Wehran-New York, Inc.

July 21, 1998 Project 85740-100.000

Re: Response to Remedial Design Report Comments Saginaw-Buffalo Site, Buffalo, NY NYSDEC Site No. 915152

Wehran-New York, Inc. (EMCON) on behalf of General Motors Corporation (GM) has reviewed the July 14, 1998 comment letter from the New York State Department of Environmental Conservation (NYSDEC) on the Remedial Design Report. The following responses have been prepared based on the NYSDEC comment letter and our July 14, 1998 telephone conversation. The report has also been revised to reflect these changes.

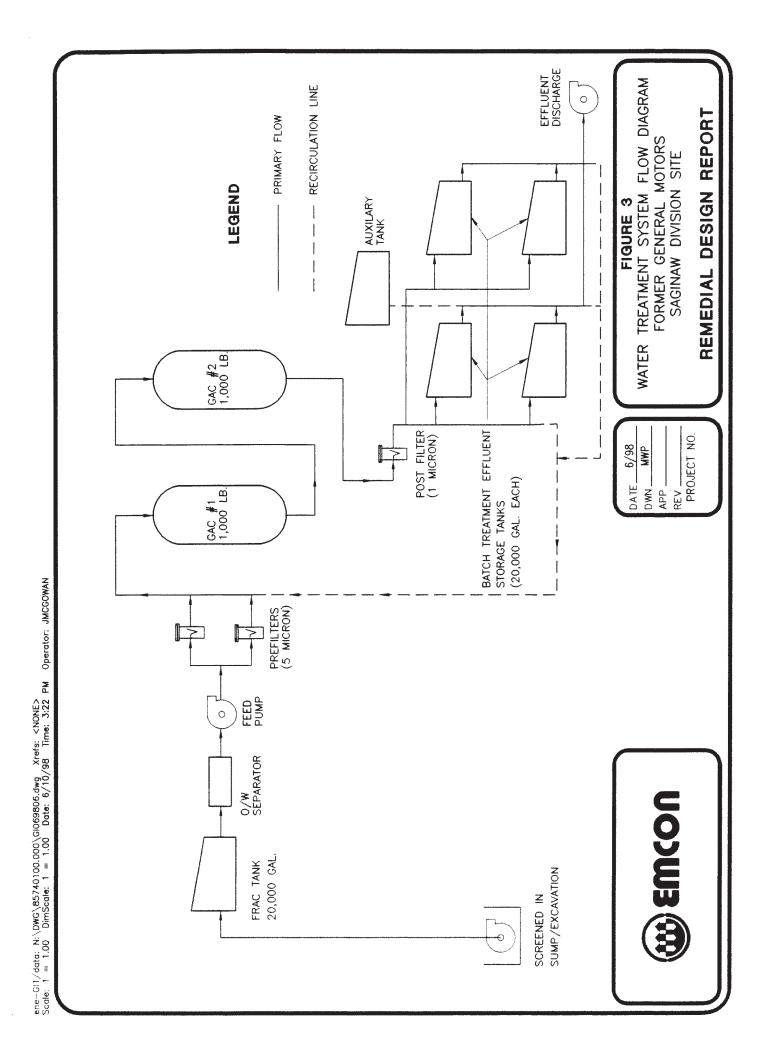
5. Section 2.1.3, Paragraphs 5 and 6: Post-excavation sampling to confirm the cleanup level is not clear. Post-excavation soil samples from the bottom of the excavation should be collected from 10-feet grid nodes. For each confirmatory soil sample, four nodal samples can be composited. The total number of post-excavation samples from the bottom shall depend upon the number of such grids. Depending on the size of excavation, two to three composite soil samples shall be collected from each wall to be tested in the laboratory. A sufficient number of QA/QC samples should also be collected to ascertain the quality of the data. Post-excavation confirmatory samples shall be collected in the presence of a NYSDEC representative. No backfilling should start until the laboratory confirmatory data is available verifying that no further excavation will be required. The material to be used for backfilling should either be from a reliable clean source or should be tested prior to its use.

The confirmatory sampling of the excavation has been amended pursuant to our July 14, 1998 conversation. Post-excavation soil samples from the bottom of the excavation will be collected based on a 25-foot grid. Assuming the excavation is 100 feet by 100 feet, this would create 16 sampling squares. One composite sample will be submitted for analysis from each square. Each composite sample will be generated from five grab samples: one grab sample collected from each grid node (for a total of four) and one collected from the center of each square.

Two composite samples will be generated from each of the side walls (for a total of eight) and sent for laboratory analysis. Duplicate samples will be collected at the rate of 10% and sent for laboratory analysis for QA/QC purposes (two from the floor and once from the walls, based on the current number of samples). All confirmatory sampling will be conducted in the presence of a NYSDEC representative.

Backfill material will be required to be certified by the remedial contractor's supplier as to its contents. Backfilling of the excavation will not begin until results of the confirmatory samples are received. Analyses are being conducted on a 24-hour turnaround basis.

1. OU 2 Groundwater, Pgs. 1-3 and 5-4: Monitoring well MW-202 is included in figure 5 but is not mentioned on Pgs. 1-3 and 5-1.

Monitoring well MW-202 was shown on Figure 5 since it is an existing feature at the site, but was not included in the list of wells to be monitored on pages 1-3 and 5-1 because it was not included in the monitoring list printed in the Record of Decision (ROD). Based on our conversation of July 14, 1998, GM has added MW-202 to the monitoring and maintenance list.
